**re:** **Grading and Site Servicing Plans Review**  
**Proposed Residential Development**  
222 Baseline Road – Ottawa, Ontario

**file:** PG6324-MEMO.01

Further to your request and authorization, Paterson Group (Paterson) prepared the current memorandum to provide a review from a geotechnical perspective for the grading and site servicing plans for the proposed residential building at the aforementioned site. This memorandum should be read in conjunction with Paterson Geotechnical Report PG6324-1 dated September 23, 2022.

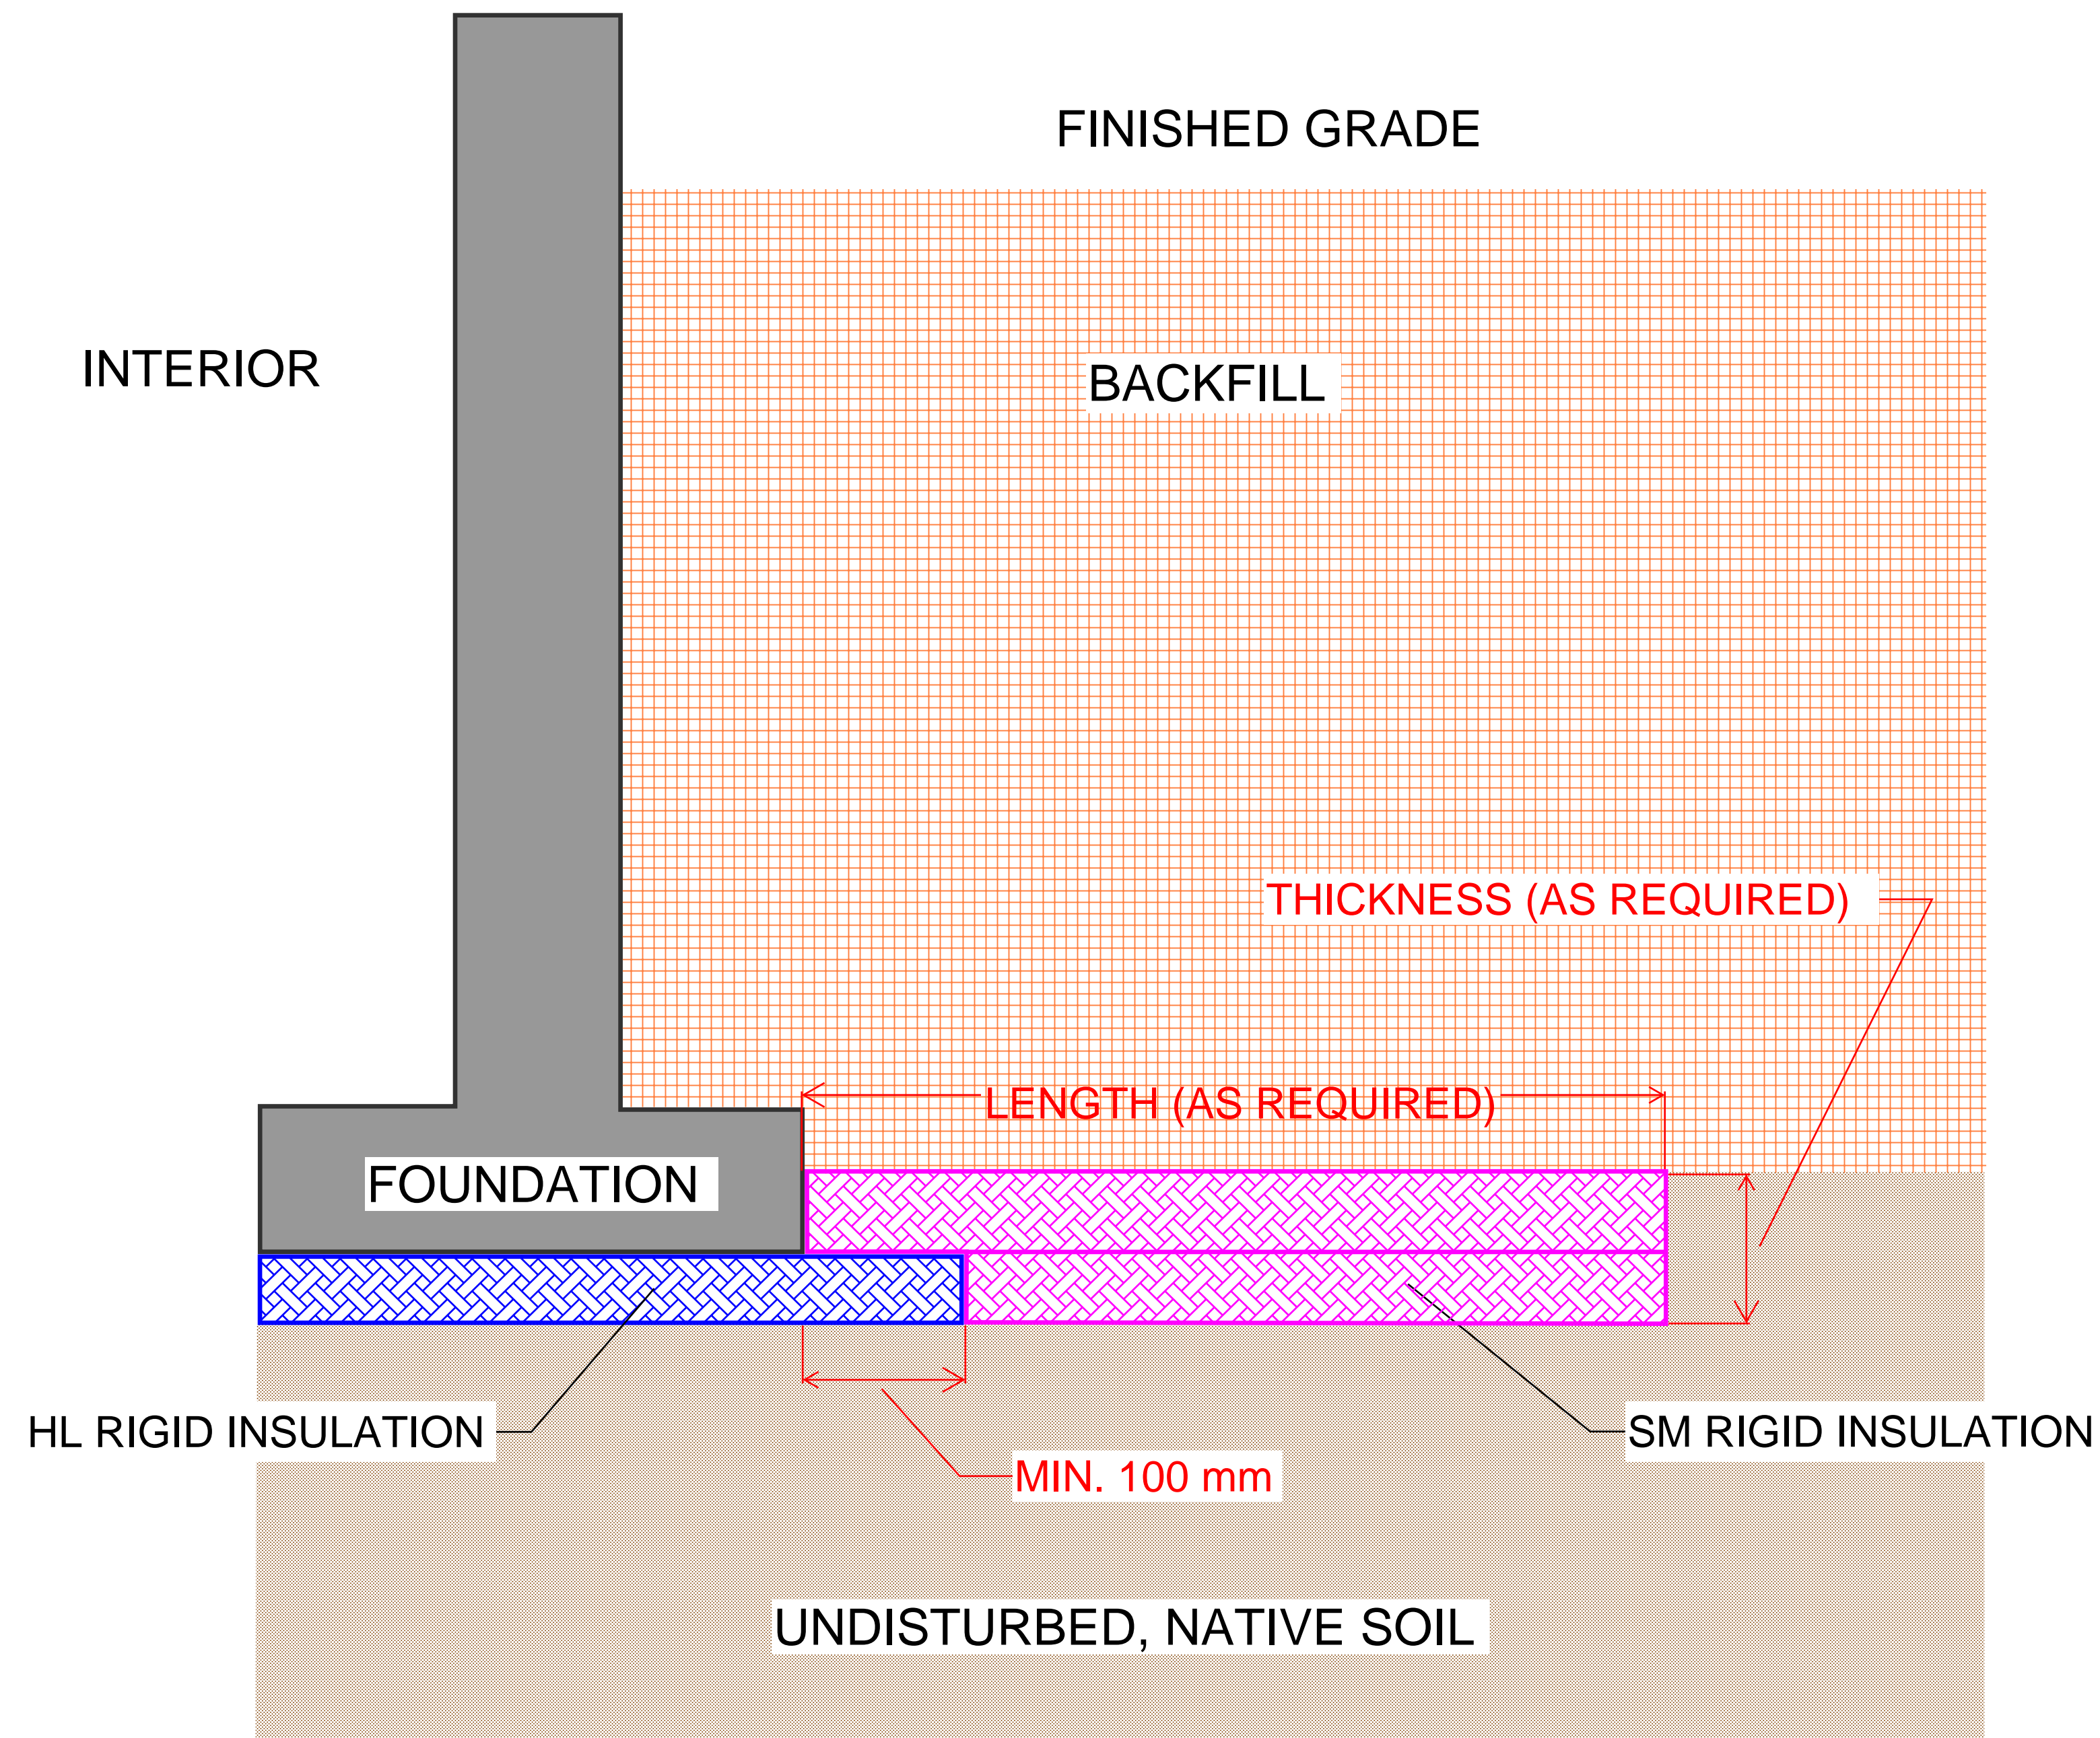
All rigid insulation placed below the footings should consist of either Dow Chemical High-Load 40 (HL-40), Styro Rail SR.P400, or equivalent approved by Paterson. The rigid insulation placed below the footings should extend a minimum of 100 mm beyond the exterior edge of the footing. Styrofoam (SM) rigid insulation can be used beyond to extend beyond the footing face (above USF). Reference should be made to Figure 3 – Typical Rigid Insulation Detail, attached to this memorandum.

All rigid insulation should consist of either Dow Chemical High-Load 40 (HL-40), Styro Rail SR.P400, or equivalent approved by Paterson. The placement of all insulation within the service trenches must be reviewed and approved by Paterson personnel at the time of construction. Reference should be made to Figure 3 – Typical Rigid Insulation Detail, attached to this memorandum.
